Supplement to Final Environmental Statement

related to construction and operation of
Clinch River Breeder Reactor Plant

Docket No. 50-537

October 1982

Figure A2.1 Population distributions within 10 and 50 miles of the proposed CRBRP site. The top number in each sector is the total for 1980; the bottom number is the estimate for 2030. The totals within a 10-mile radius include resident and transient population. (Replaces FES Fig. 2.6.)

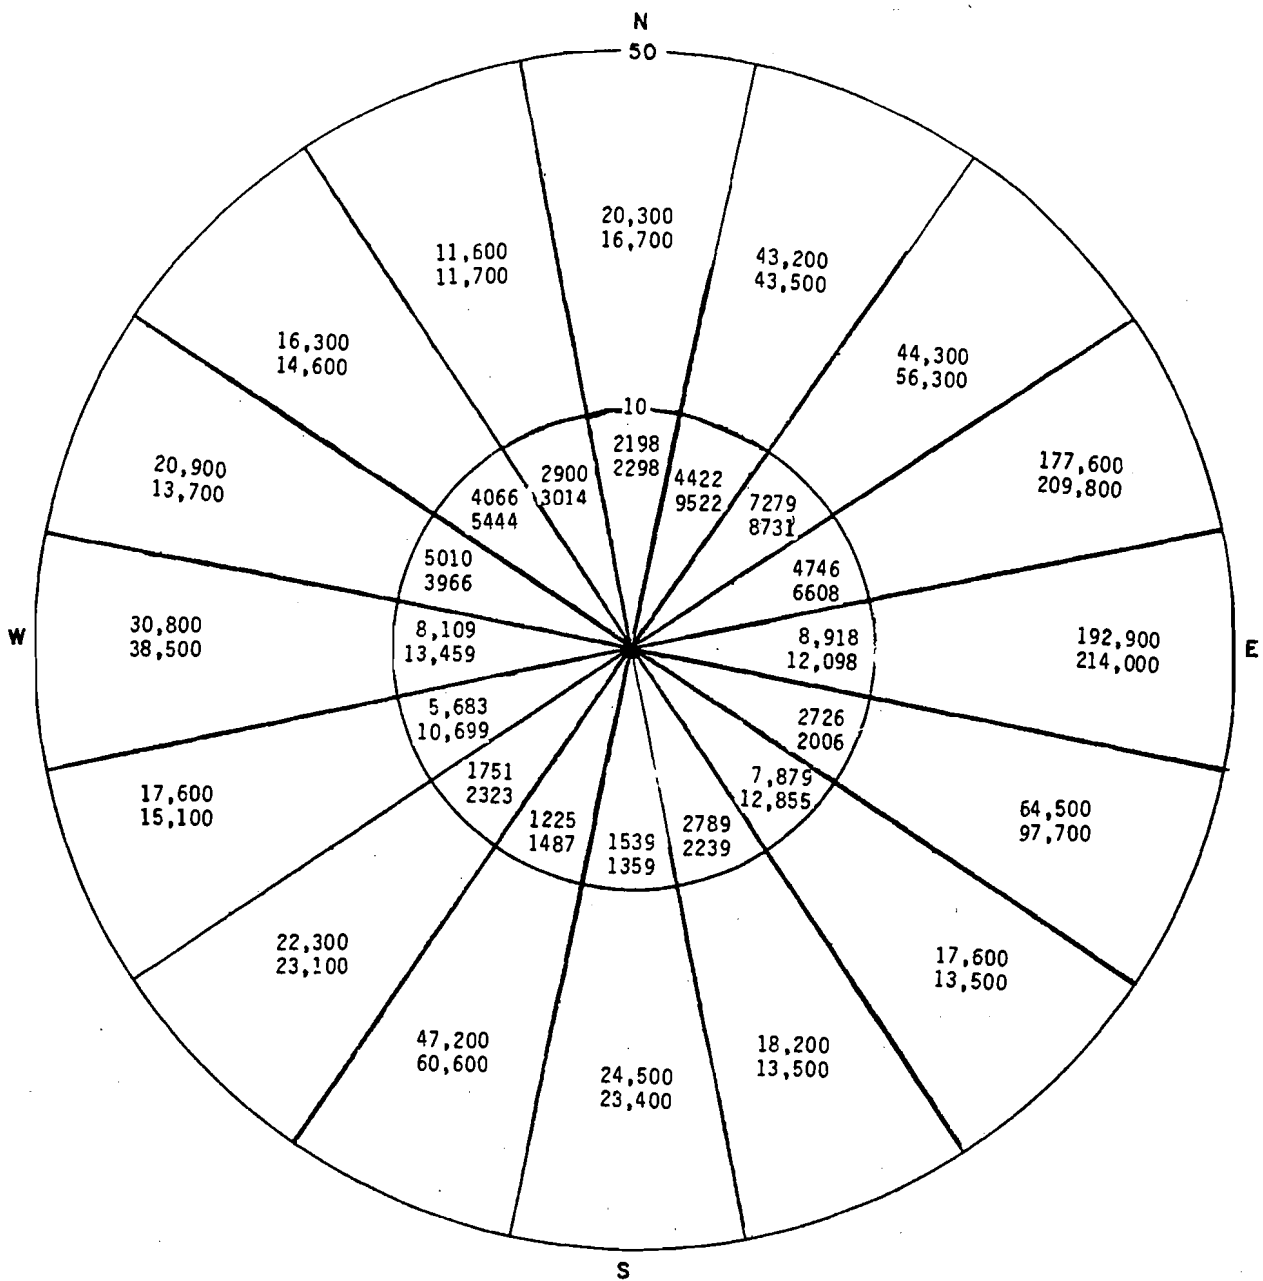
Within a 50-mile radius from the plant, Knoxville and Oak Ridge are the largest urban centers, with 1980 populations of 183,139 and 27,662 respectively; 16 other centers have populations between 2500 and 15,000 (ER Table 2.2-1). In 1980 the 10-mile radial area had a resident population of 52,040, and the 50-mile area, 830,840. The corresponding estimates for 2030 are 67,580 and 933,280. Figure A2.1 shows population distributions for 1980 and 2030, from 0 to 10 miles and from 10 to 50 miles from the site.

Figure A3.2 Main building layout of CRBRP

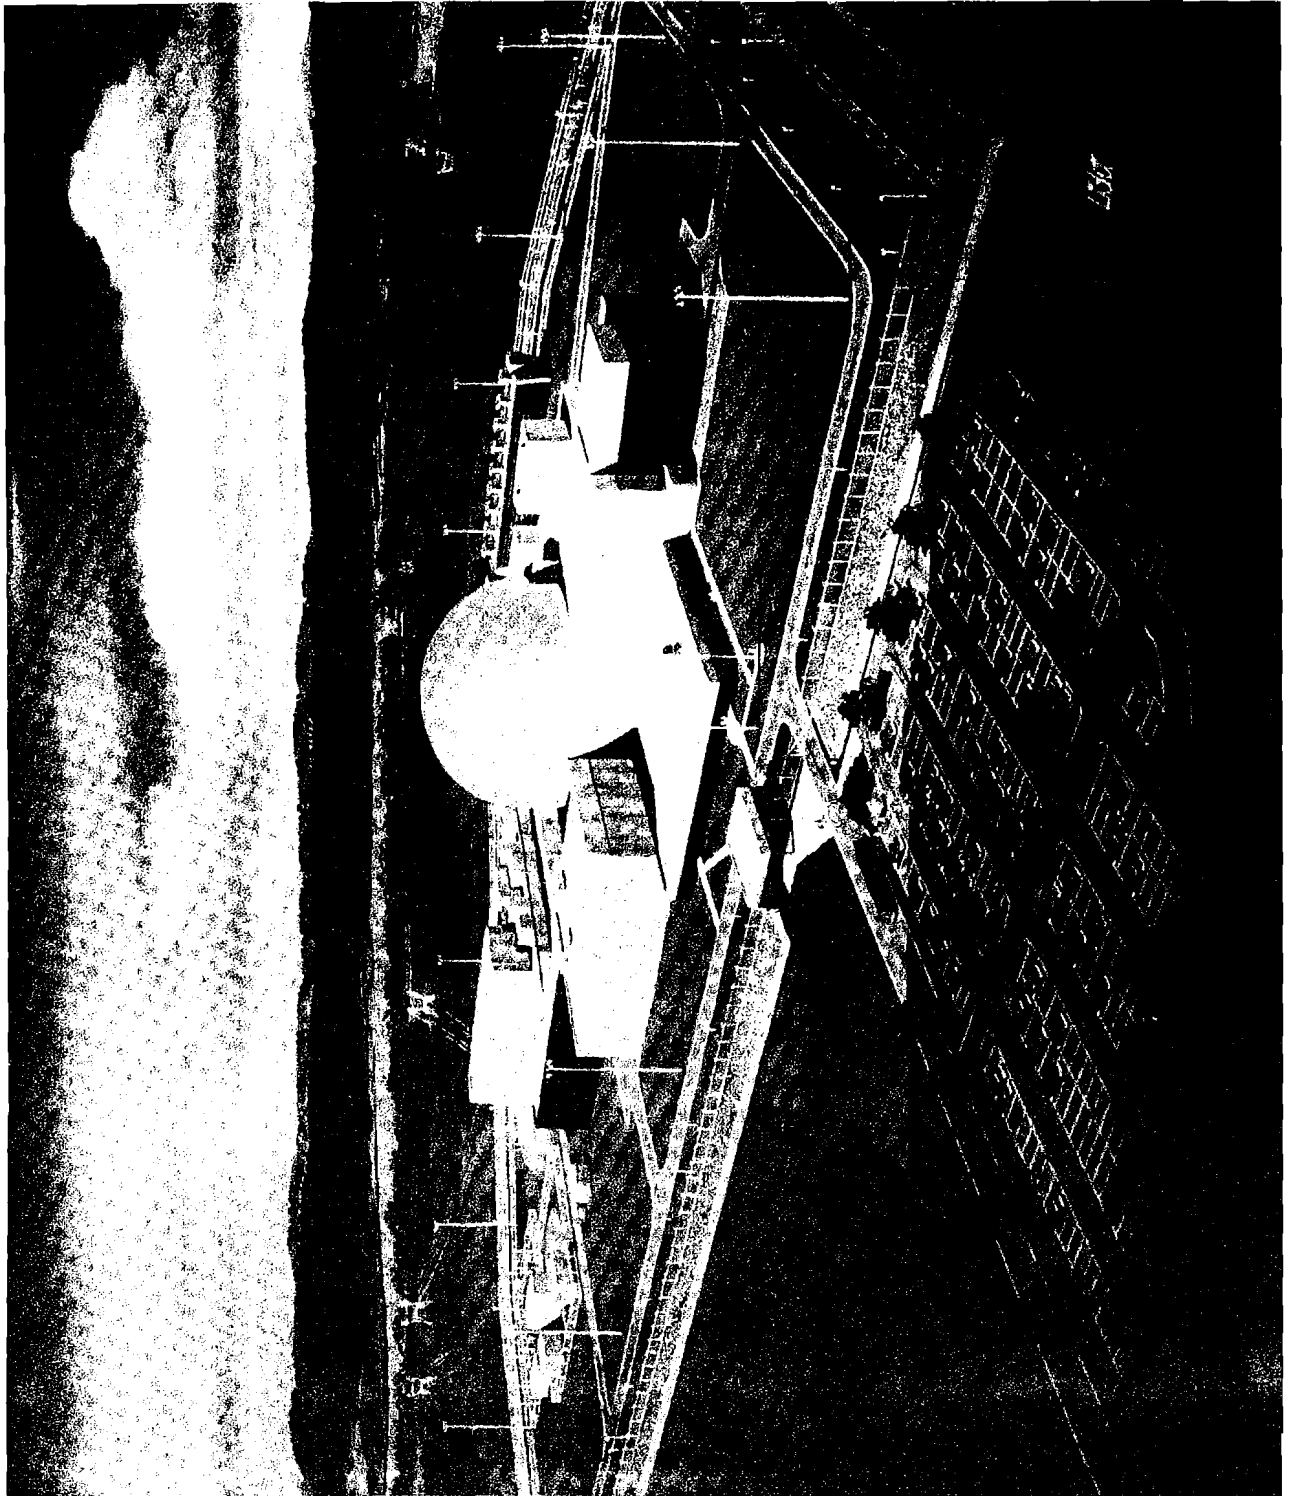
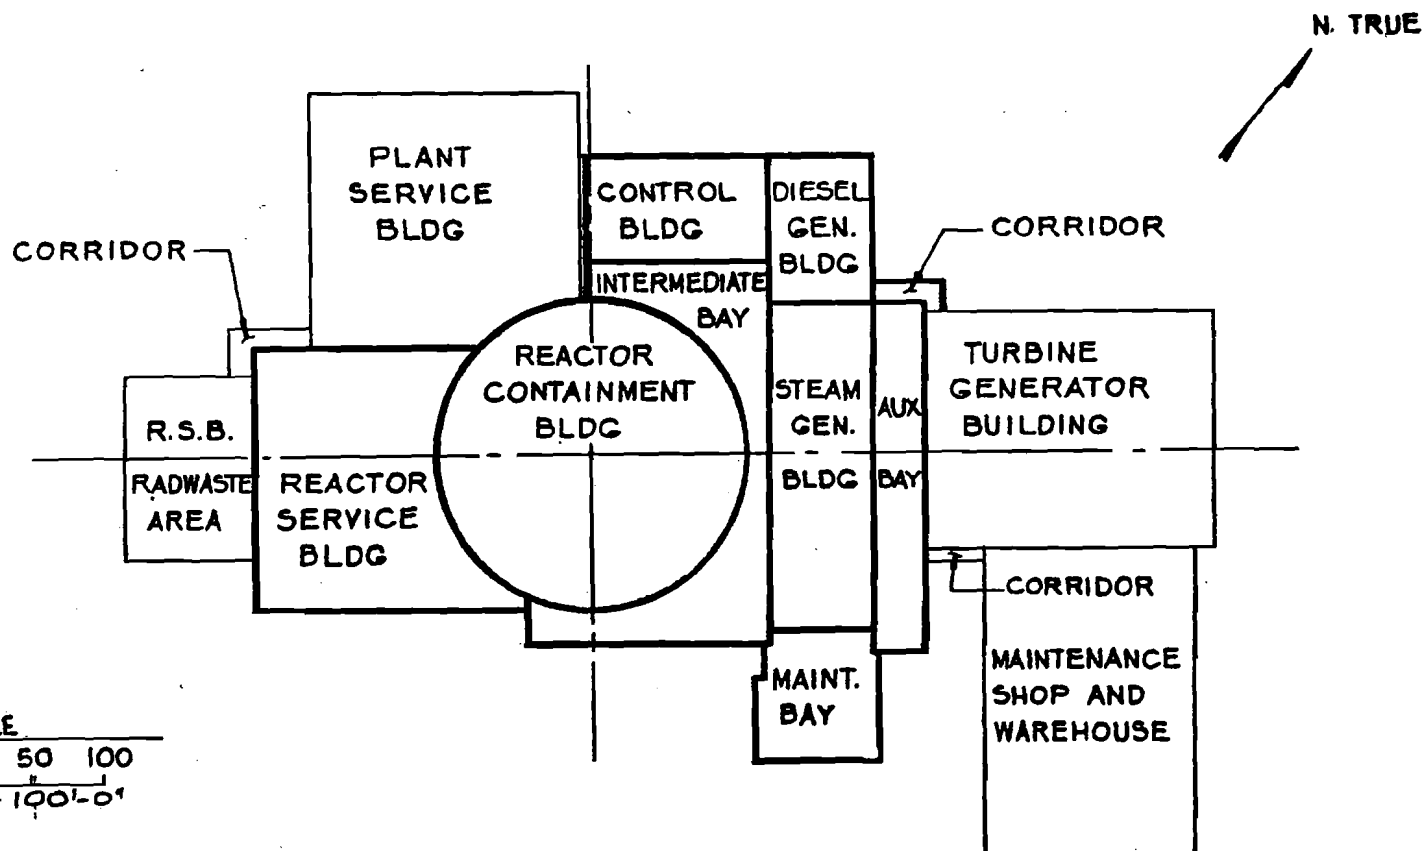
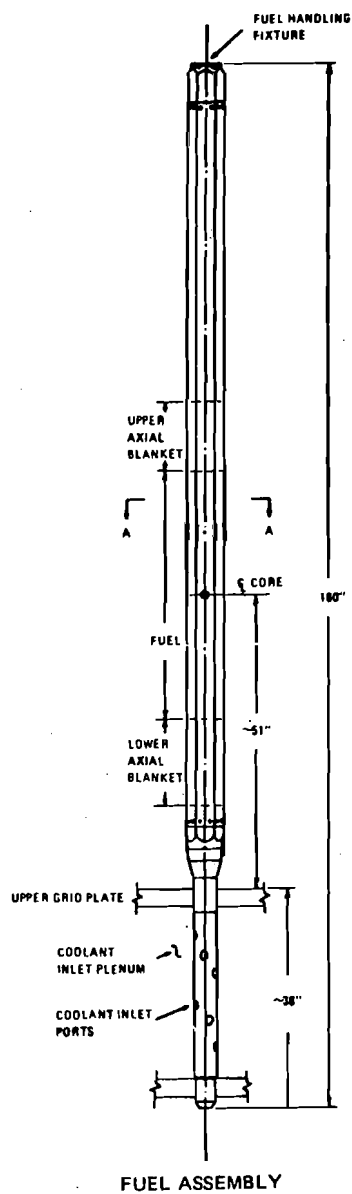
A conceptual architectural rendering of the plant (FES Fig. 3.1) and the building layout (FES Fig. 3.2) have been revised as shown in Figures A3.1 and A3.2.

Figure A3.4 Average annual water use rates (replaces FES Fig. 3,6)

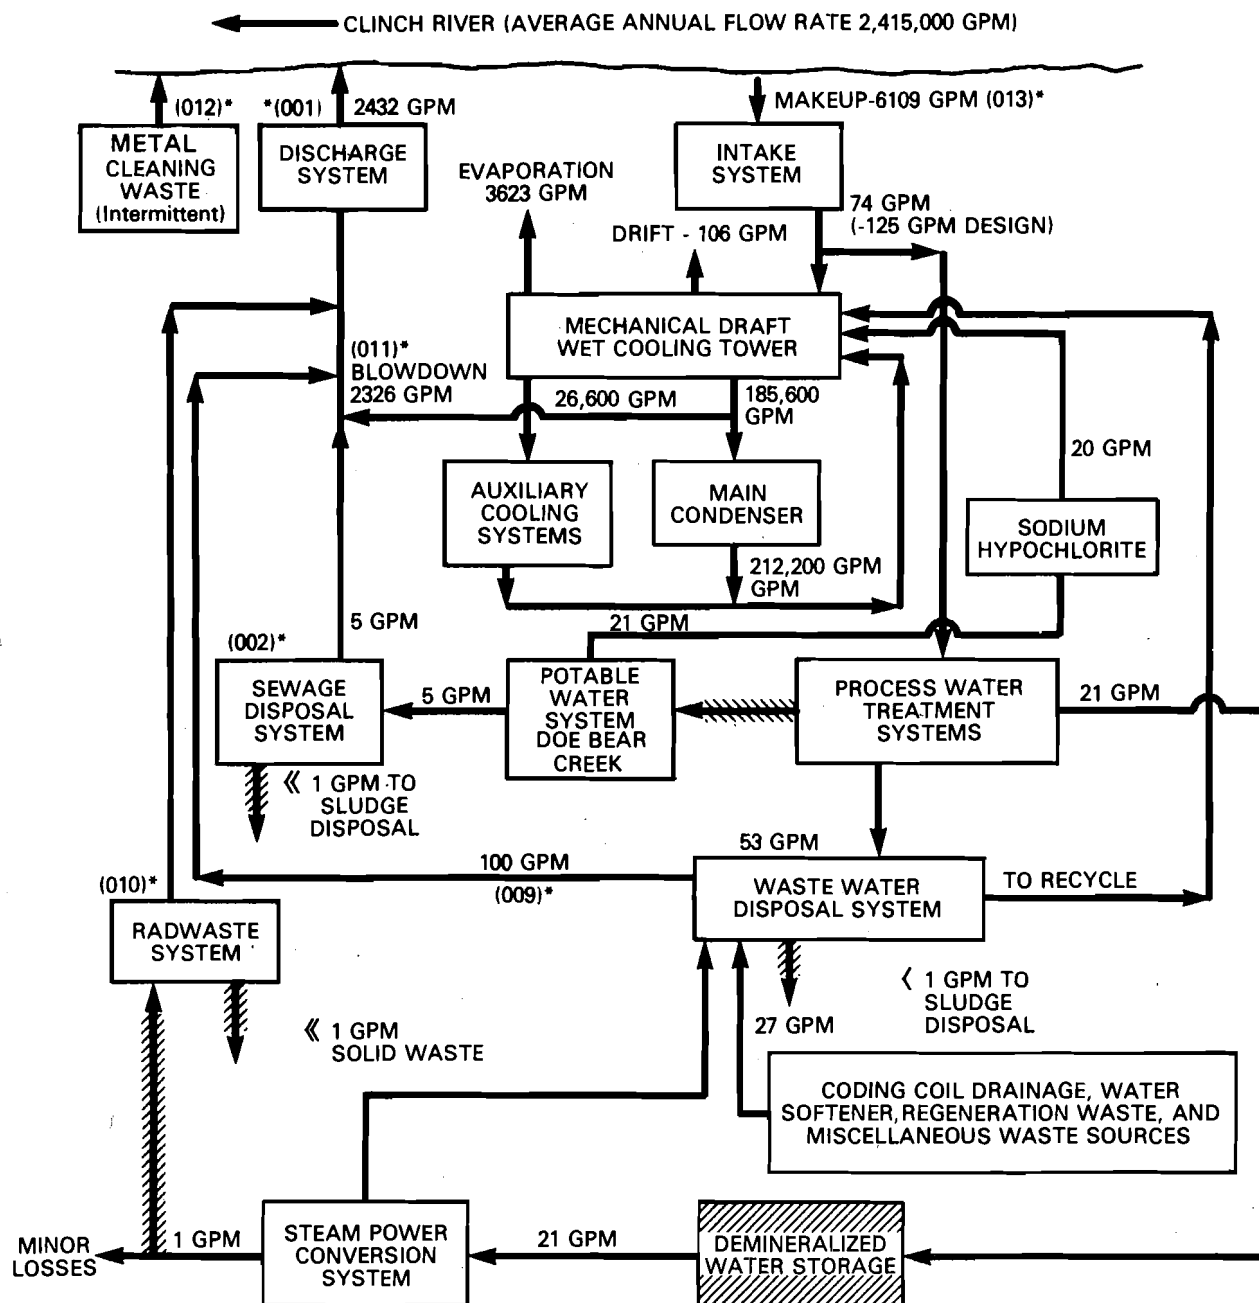
Consumptive use of water at the plant will be essentially the result of evaporation in the cooling towers. As shown in Figure A3.4, an average of 3729 gpm would be lost by evaporation and drift from the tower out of a makeup stream of 6145 gpm. Chemicals or chemical species expected to be in plant cooling water discharged to the river are shown in Table A3.2 of this assessment (ER Am VIII, Table 3.6-1, which replaces FES Table 3.5). The comparison of chemical concentrations in the station effluent shown in FES Table 3.6 have not been revised here because the NPDES Permit Rationale demonstrates how Federal effluent limitations and state water quality criteria are considered in developing permit limitations (see Appendix H).

EPA-7--Figure A3.4: Information has been added to Figure A3.4 in response to this comment.

Figure A3.5 Mechanical draft wet tower blowdown
(replaces FES Fig. 3.7)

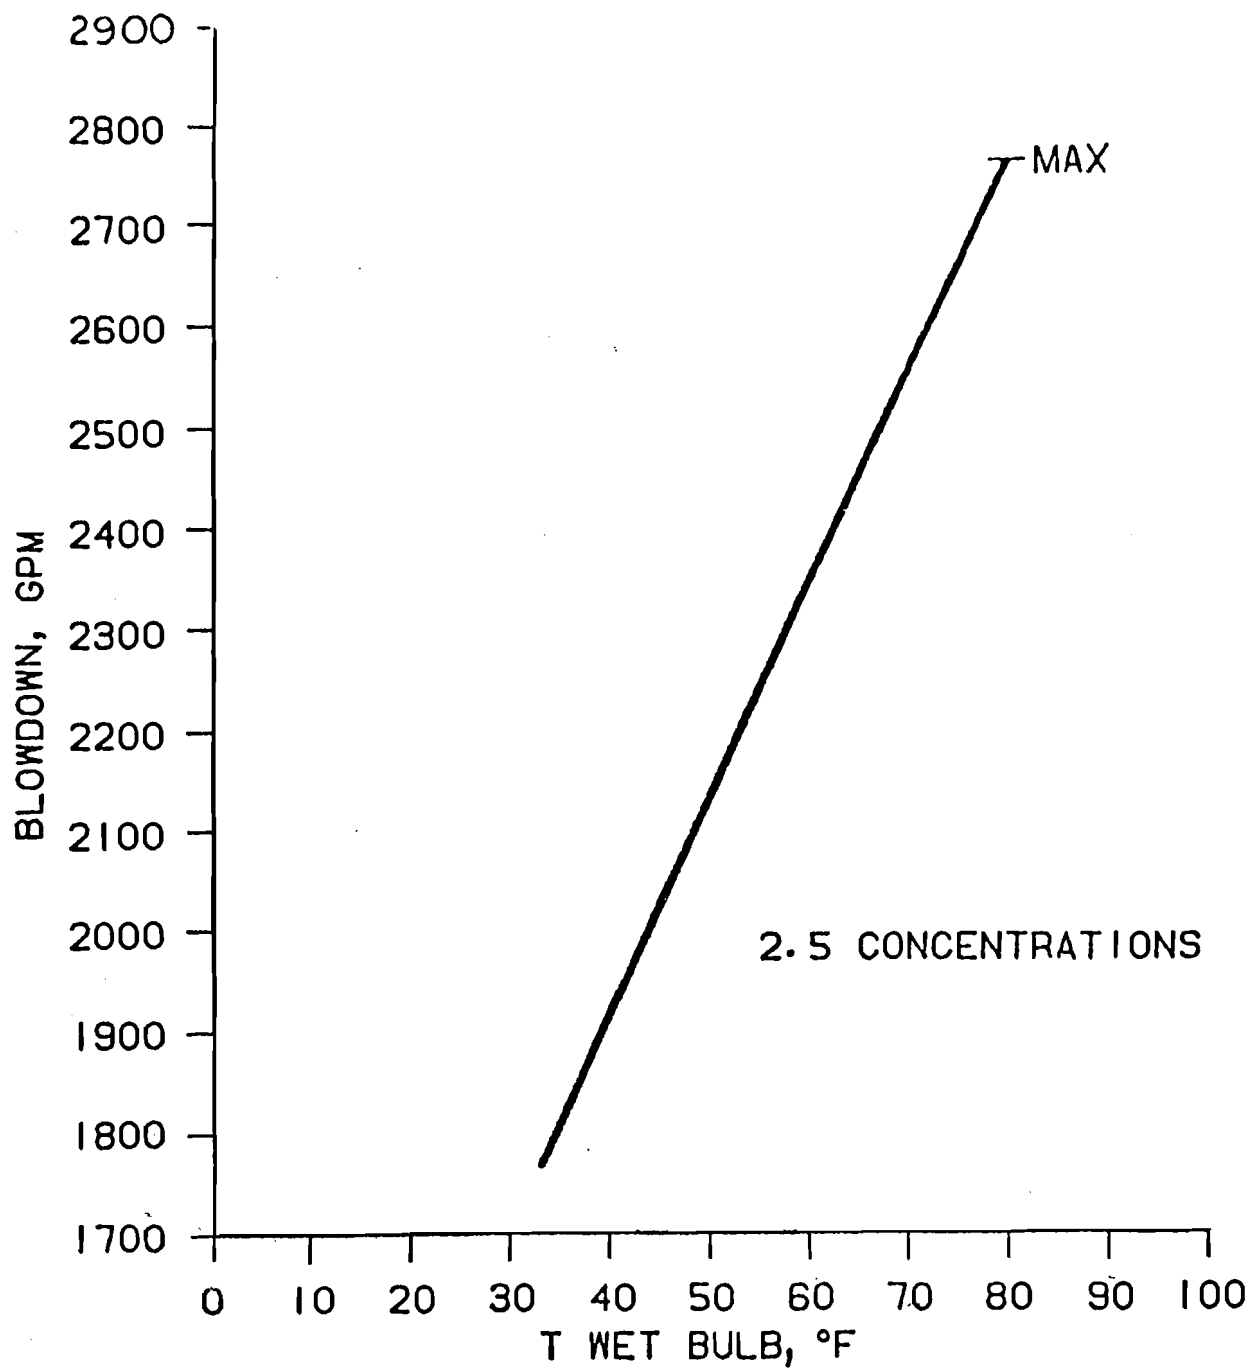
Figure A3.5 illustrates the relationship between the wet bulb temperature and the blowdown rate (ER Fig. 3.4-4); it replaces FES Figure 3.7. The auxiliary cooling water systems design has been changed to provide 27,000 gpm instead of 24,000 gpm at 95°F or less.
